TECHNICAL SERVICE BULLETIN

Vibration/Pulsation From Brakes - Brake Pad Material Stuck To Rotor

21-220624 August
2021**Model:**

Ford 2021 Mustang Mach-E

Figure 1

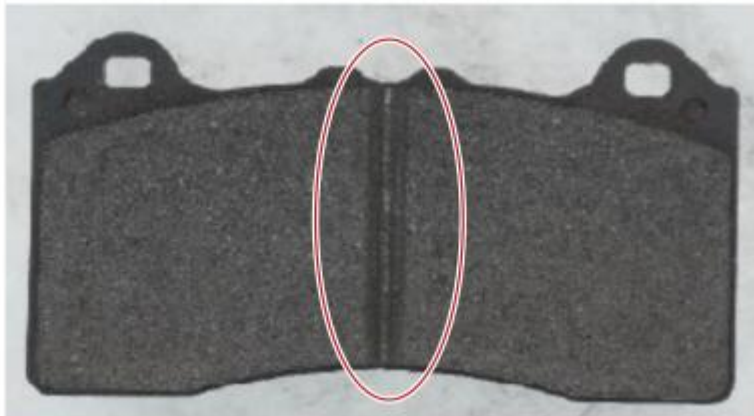
Issue: Some 2021 Mustang Mach-E vehicles may exhibit a vibration or pulsation from the brakes. This may be due to brake pad material bonded to the rotor. To correct the condition, follow the Service Procedure steps to replace the brake pads and resurface the rotors.

Figure 2 - Original Front Brake Pad

Figure 3 - Revised Brake Pad

1. Replace the front brake pads with the revised brake pads that do not contain the center V channel. Refer to Workshop Manual (WSM), Section 206-03.
2. Resurface the front brake rotors to remove the brake pad material. Refer to WSM, Section 206-00.
